AREA WALK-BY CHECKLIST

IP2

Area Walk-By Checklist (AWC) AWC-013

Location: Bldg. SWSTR PIT Floor El. 5'-9" Room, Area¹ Zem Strainer Pit

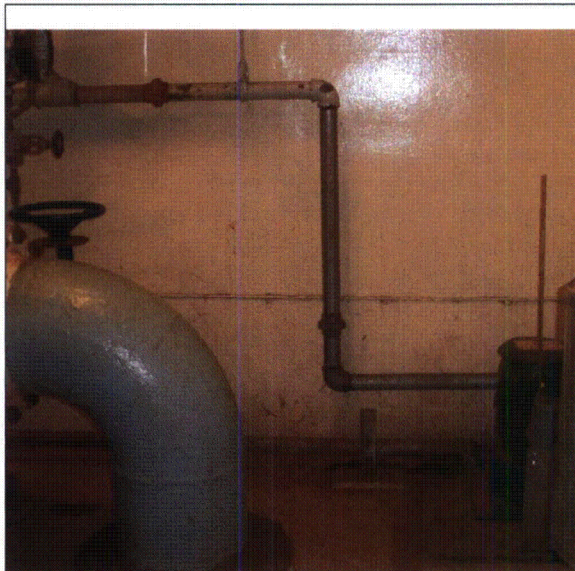
There is one threaded pipe on the north wall for the 26 sump pump discharge. This threaded pipe is judged adequately supported to preclude leakage and/or spray caused by a seismic event.

Note: Threaded pipe for the 26 sump pump discharge.

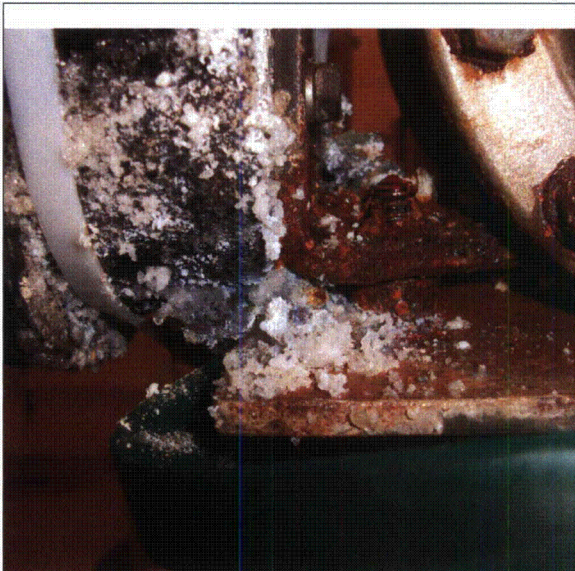
Note: Salt crystals found on SWN-625-X3 22SWP Equalizing valve DPI-5001-S.

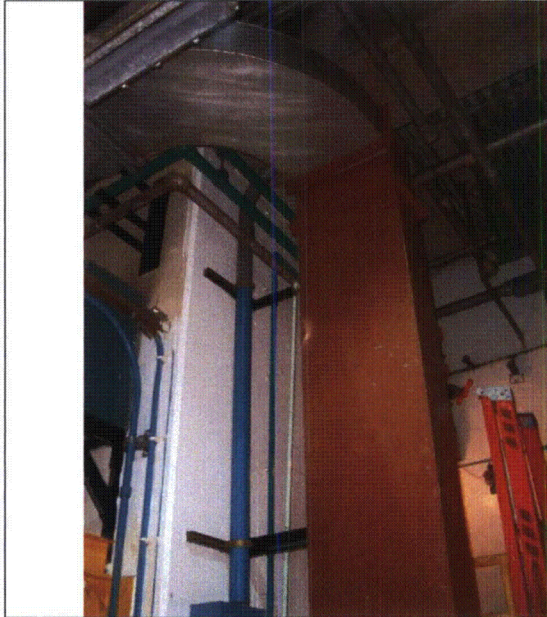
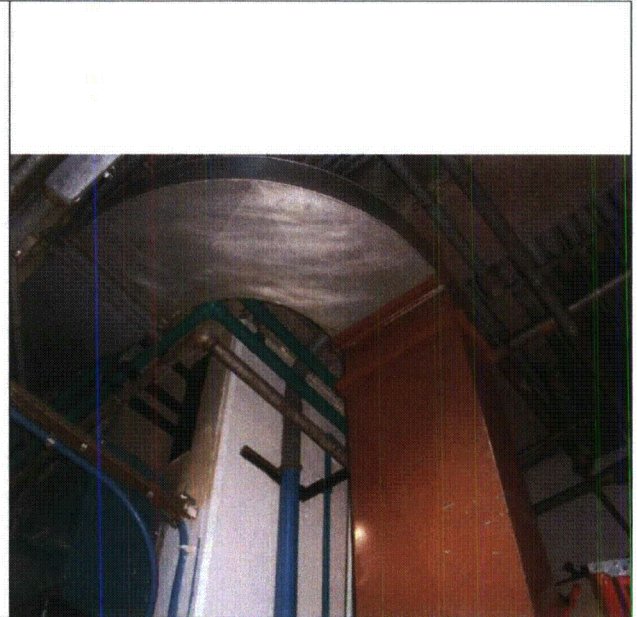
Note: Duct work with excessive span between supports.

Note: Duct work with excessive span between supports.

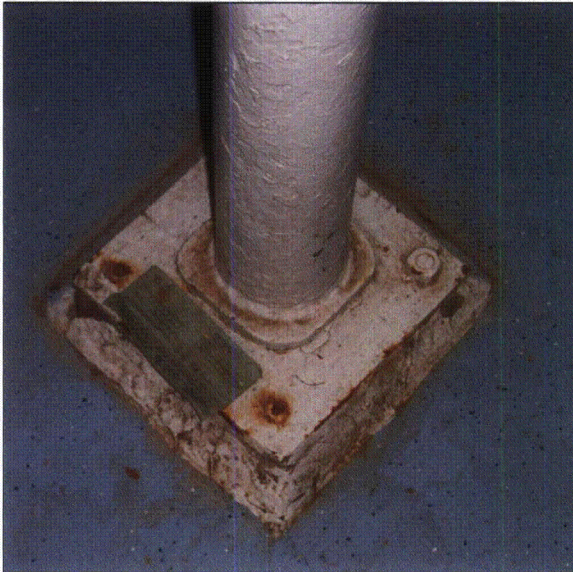
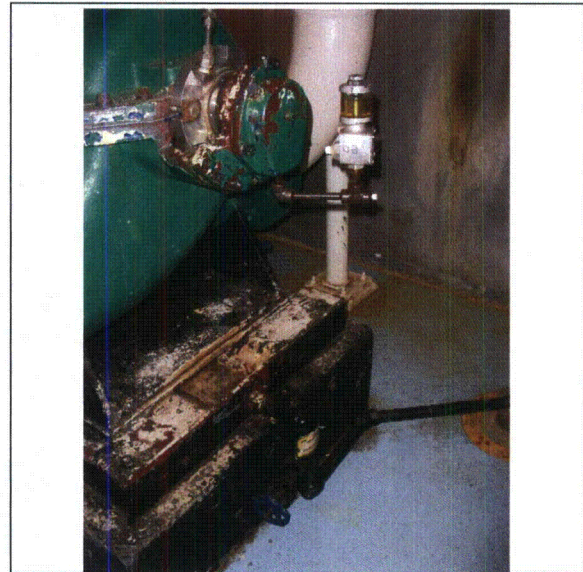
Note: Pipe support for CCW missing two anchor bolts. Existing work order tag is WRT IP2-05-0522.

Note: Pump 23 CCW pump is leaking oil onto the floor.

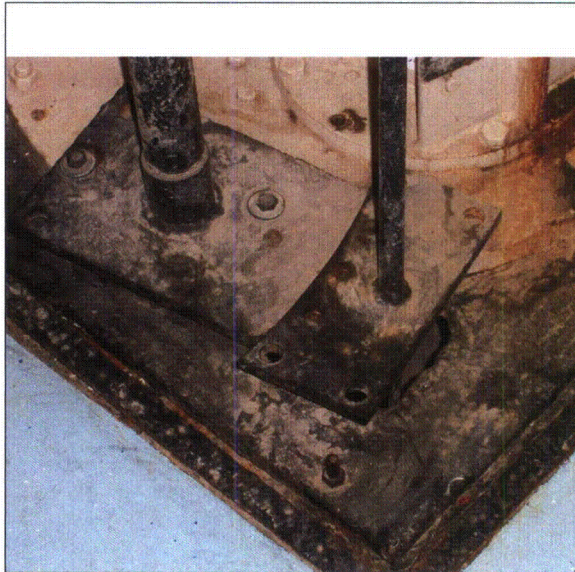
Note: 23 Sump Pump missing bolts on the float rod guide.

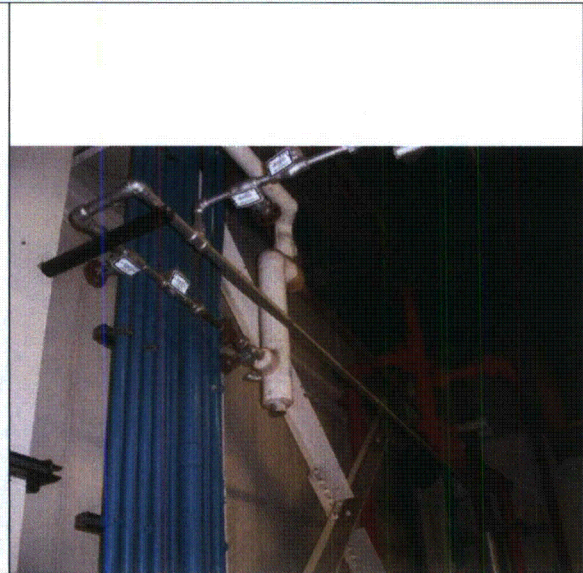
Note: Area heater piping. Pipe of concern is the galvanized pipe that parallels the building cross bracing plane.

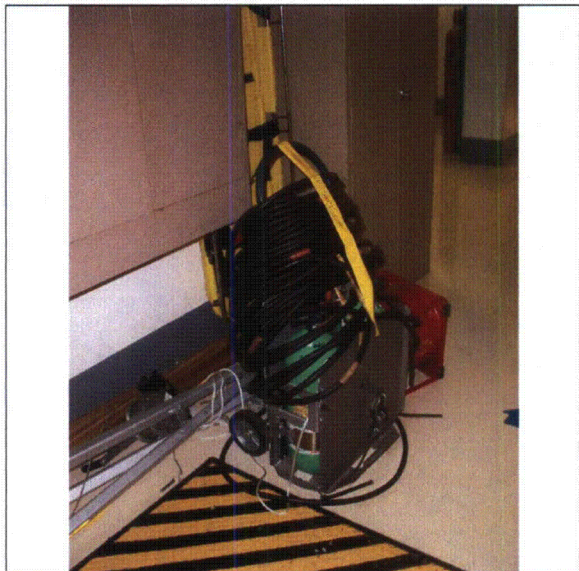
Note: Tools left loose near confined space rescue gear area. CR IP2-2012-06359 issued to track resolution.

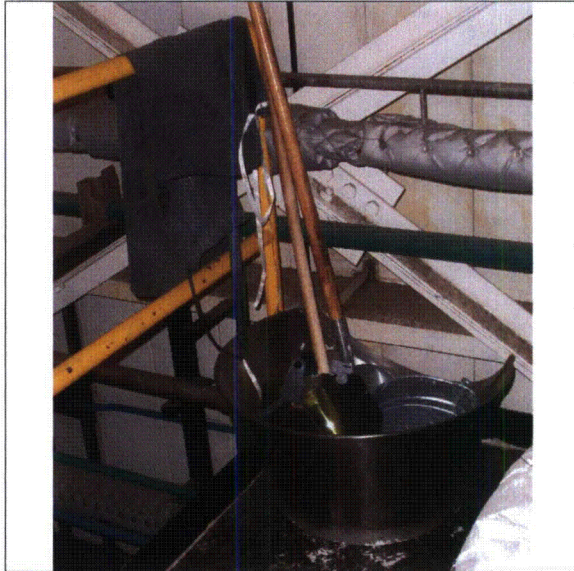
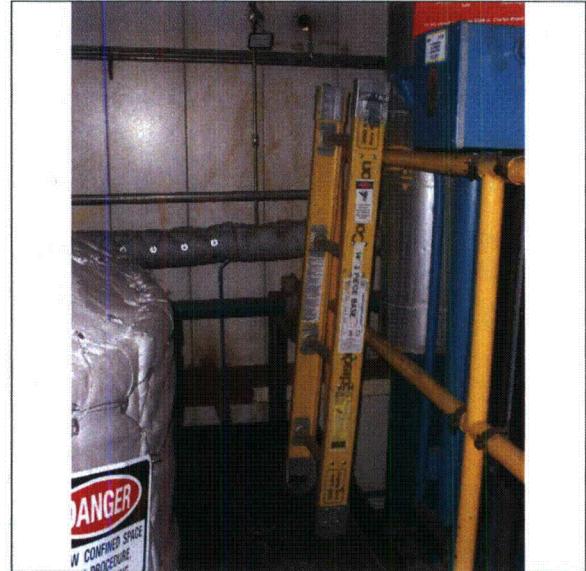
Note: Tools left leaning in corner of Boric Acid Batching platform. CR IP2-2012-06354 issued to track resolution.

Note: Ladder left unsecured on Boric Acid Batching platform. CR IP2-2012-06354 issued to track resolution.

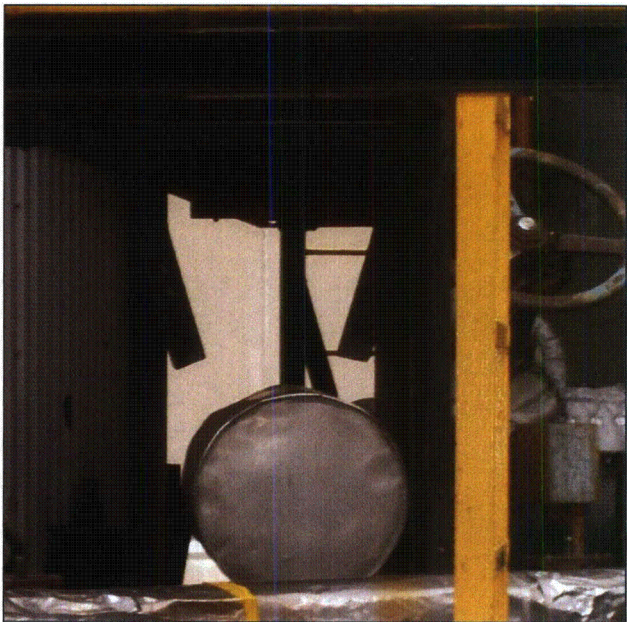
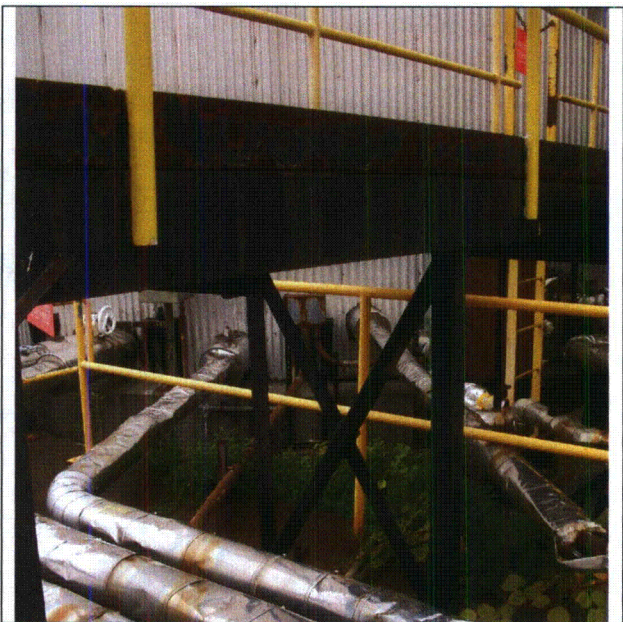
Platform between Refueling Water Storage Tank and Primary Water Storage Tank has two cross braces (bracing platform in EW direction) at RWST bolt 29 that are cut for a RWST pipe to pass through. Need to verify that a platform seismic analysis of the "as-is" platform was performed. LB-07 was performed to evaluate the condition.

Note: Platform bracing has been cut just north of RWST bolt 29 for the RWST pipe end to pass.

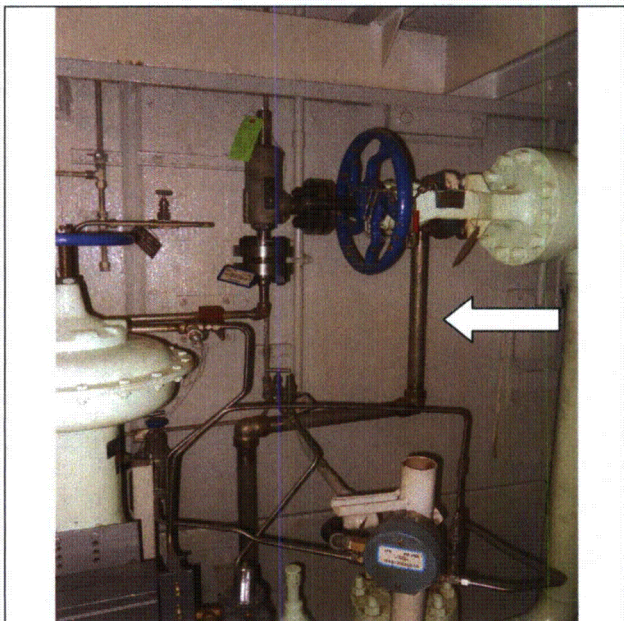
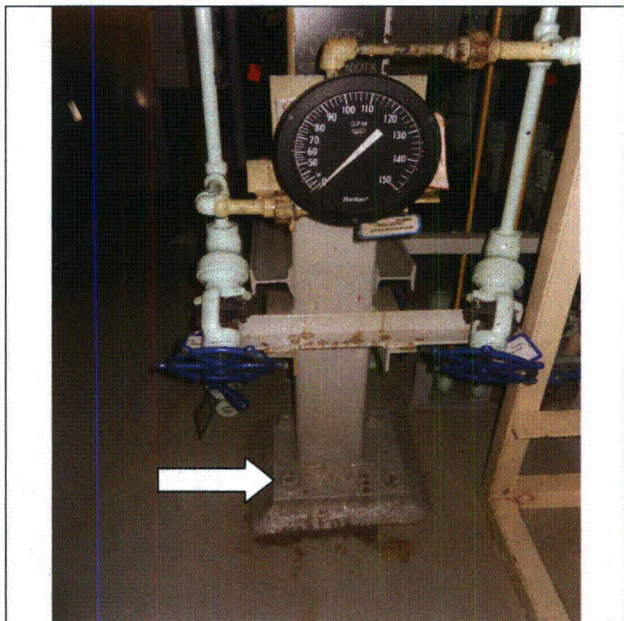
Note: 2"± diameter pipe connecting to PCV-1284 has excessive unsupported length.

Note: 5/8"± diameter anchor bolts of F1-5004 support column are not fully engaged. (Missing about 1/4").

The tension loading of the bolts anchoring the base plate for Instrument F1-5004 is very small, as discussed in the attached evaluation. As such, given that a recess of 0.172" for a 5/8" diameter bolt does not reduce the bolt tension capacity, the 8/100" larger recess observed is acceptable and we conclude that the observed condition is consistent with the licensing basis.

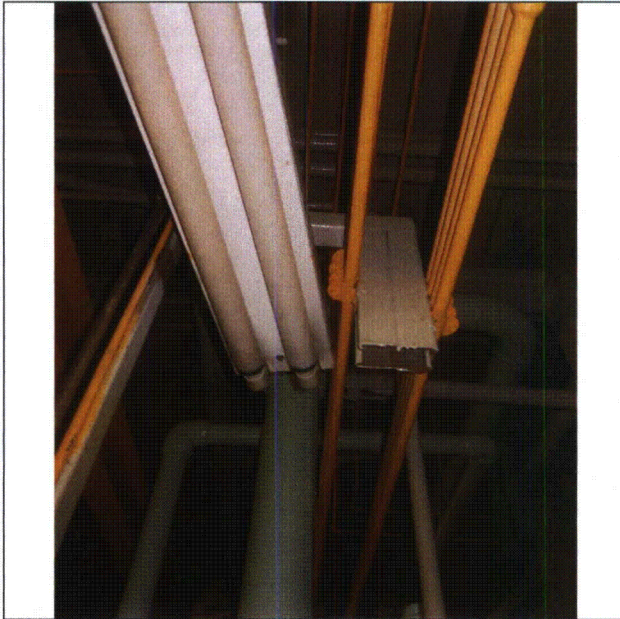
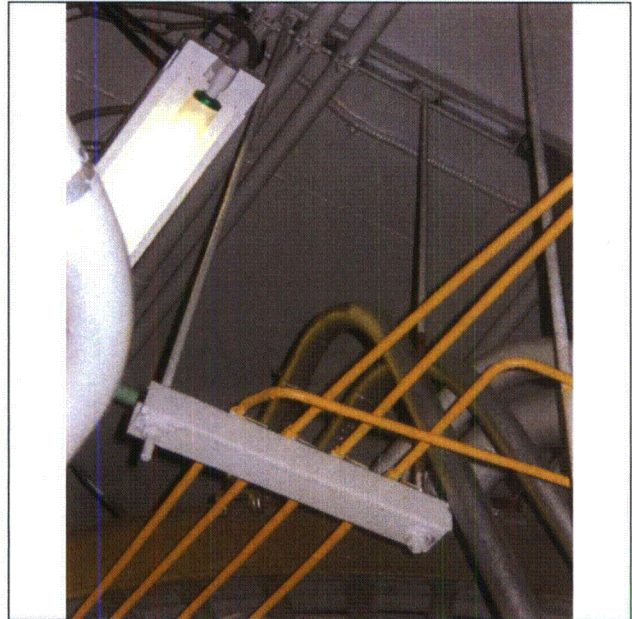
Fluorescent lights are too close to the cable tray and hanger. (total two locations for hanger proximity and one location for cable tray proximity. The interference with the cable tray occurs below the top of the rail on the tray and would not result in impact of the light fixture on the cables. The interference with the hangers occurs at approximately midspan of the vertical hanger rod. (See pictures). It is estimated that the seismic response of the light fixture impacting the hanger rod would have no affect on the integrity of the hanger rod.

Note: *Fluorescent light is too close to the tubing.*

Note: *Fluorescent light is too close to the cable tray (other end of the same light) and support hanger.*

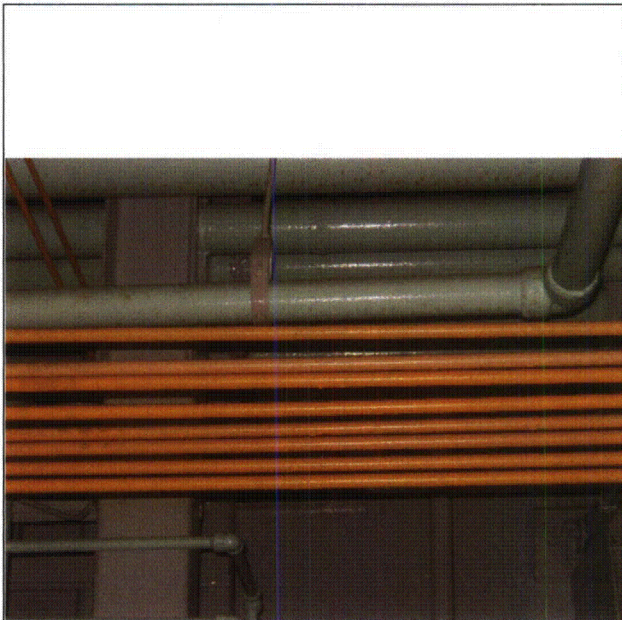
Note: Long span tubing has little separation (<1/2"). They will be interactive each other during seismic event.

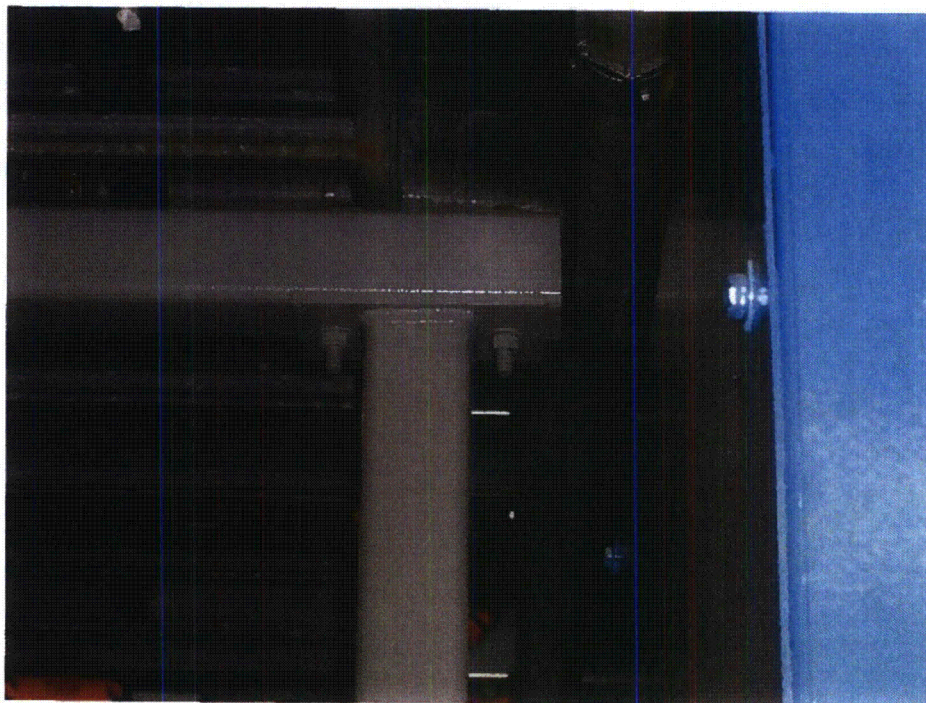
Two views of the conduit found to be approximately 3/4 inches away from the western end of the frame are shown below:

The Licensing Basis Evaluation concluded the following:

o1
 CALC.# FCX-00098-00 P.N.69982-CM-XC
 *WALKWAY PLATFORM BETWEEN RWST AND PWST

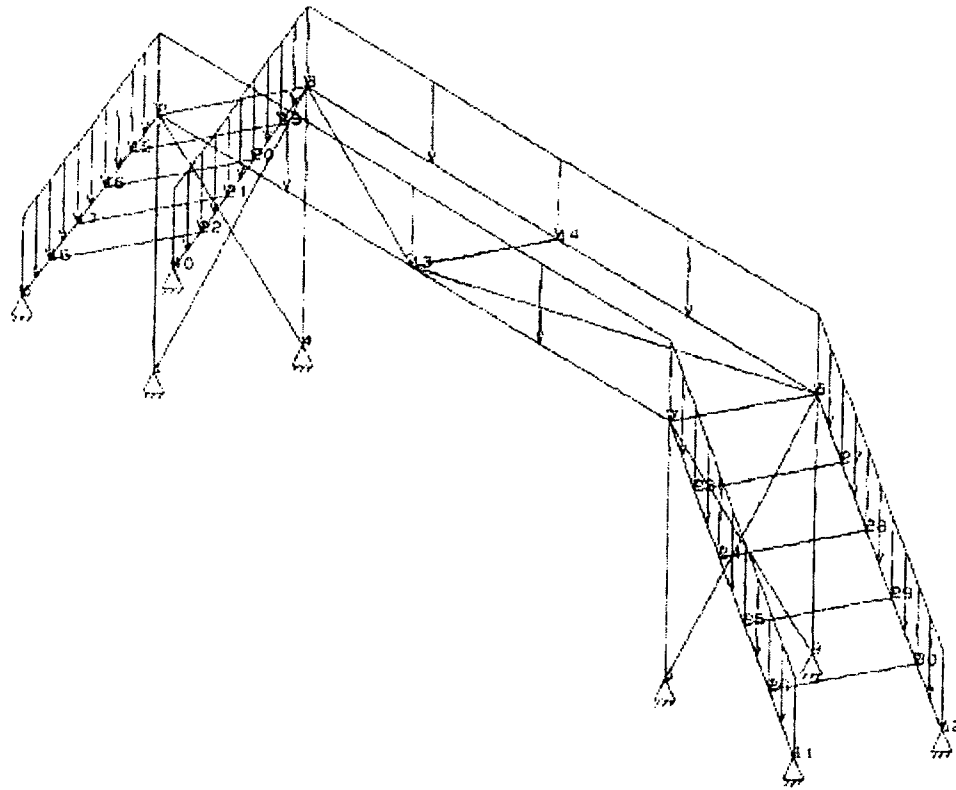
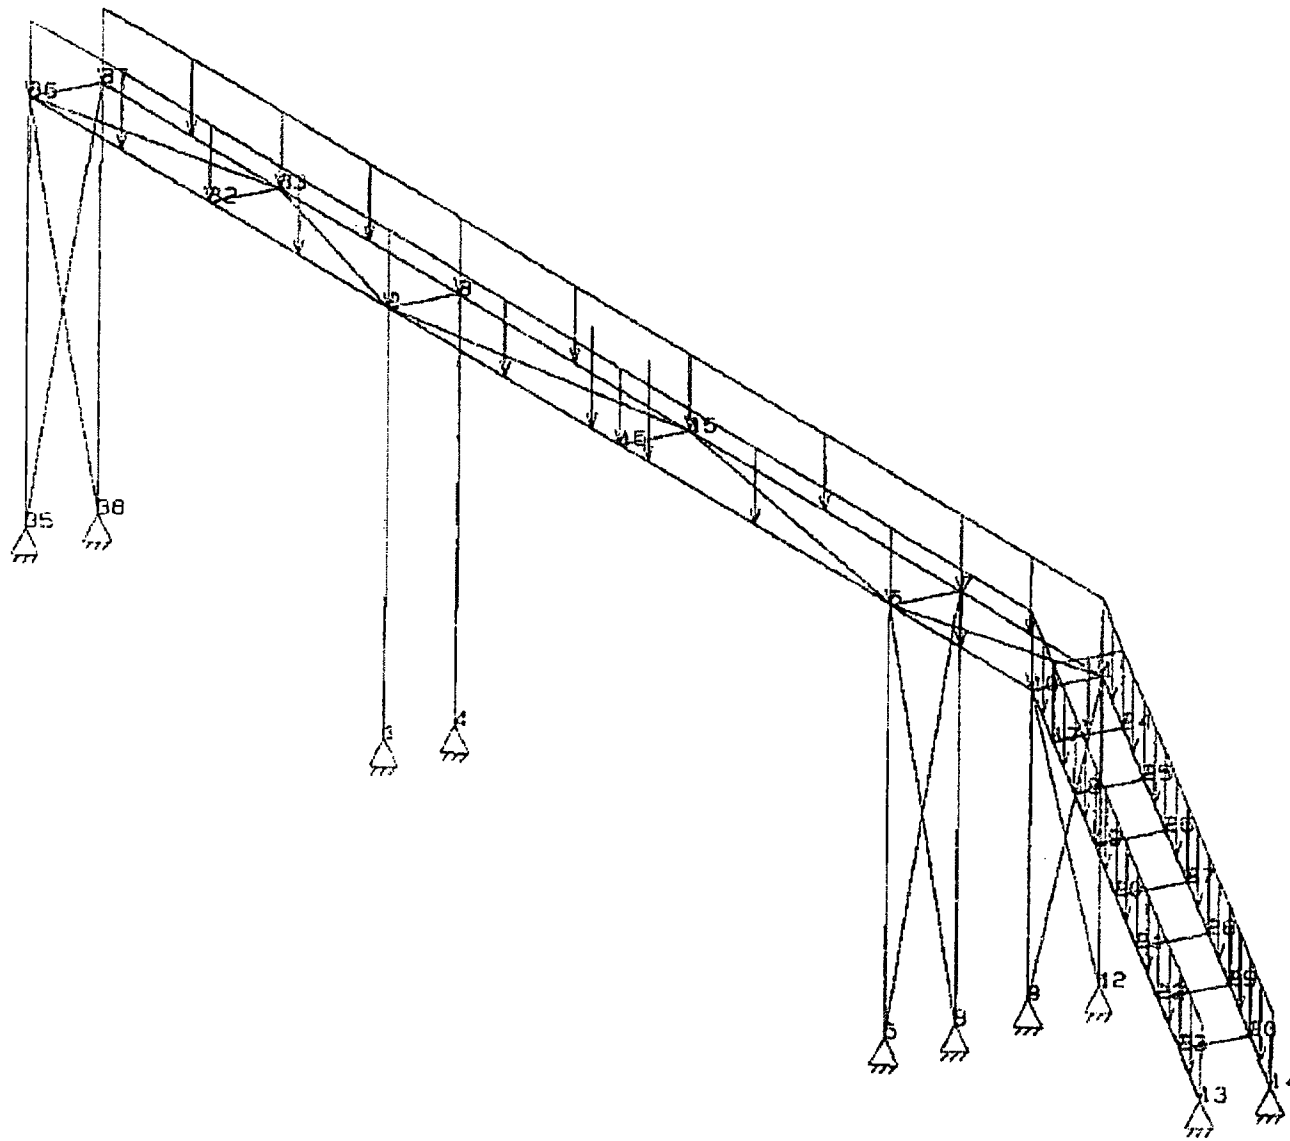
The seismic walkdown team noted that: "Platform between Refueling Water Storage Tank and Primary Water Storage Tank has two cross braces (bracing platform in EW direction) at RWST bolt 29 that are cut for a RWST pipe to pass through. Need to verify that a platform seismic analysis of the "as-is" platform was performed." The team also noted that: "Platform between 21RWST and Primary Water Storage Tank is very close to touching both tanks. Approximately 1/8" gap between tanks and platform. LBE needed to determine if gap is acceptable for both tanks 21RWST and Primary Water Storage Tank" and " Valve hand wheel at RWST anchor bolt 29 is very close to touching the platform at frame with cut bracing. Gap is very narrow, almost 1/8". Platform could potentially hit valve handle."

Calculation FCX-0098-01 performed a seismic analysis of the platform. Platform member sizes were confirmed via a walkdown. As shown in the attached excerpts from the calculation, the cut brace was so noted and the model did not include X bracing at RWST bolt No. 29.

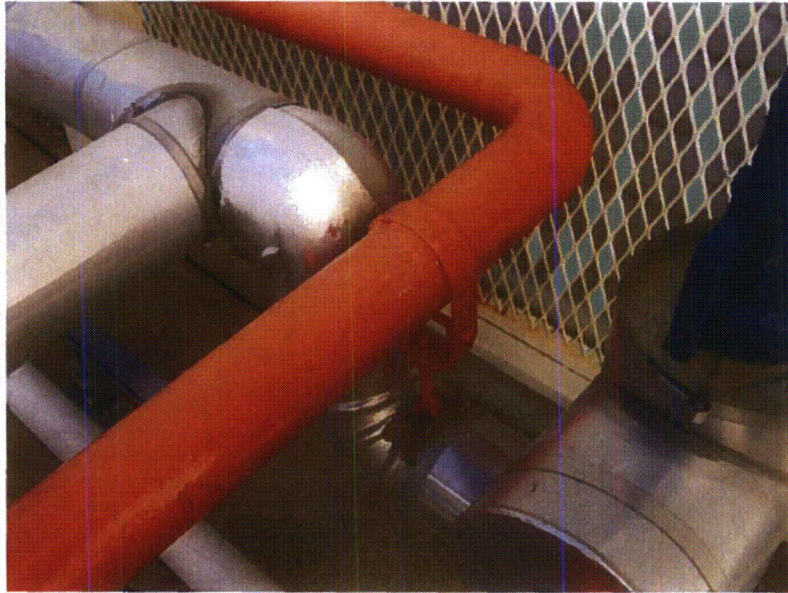
*One pipe is supported from another pipe. This is a none typical pipe support.
One pipe (insulated pipe) runs to the Emergency Domestic truck fill stop valve and the other orange pipe from the EDG building into ground near 23FOTP.*

As mentioned above, we established that Technical Report No. 91177-TR-01, "Diesel Generator Fuel Oil System, Seismic Verification Summary Report," September 1991 reports on analyses that reflected the field configuration. A section of the report covers analyses of the 1 1/2" and 1" Diesel FO Normal and Emergency Fill Lines. The analyses confirmed that the pipes and their supports are adequate under all postulated loads and load combinations, including OBE and DBE loads.
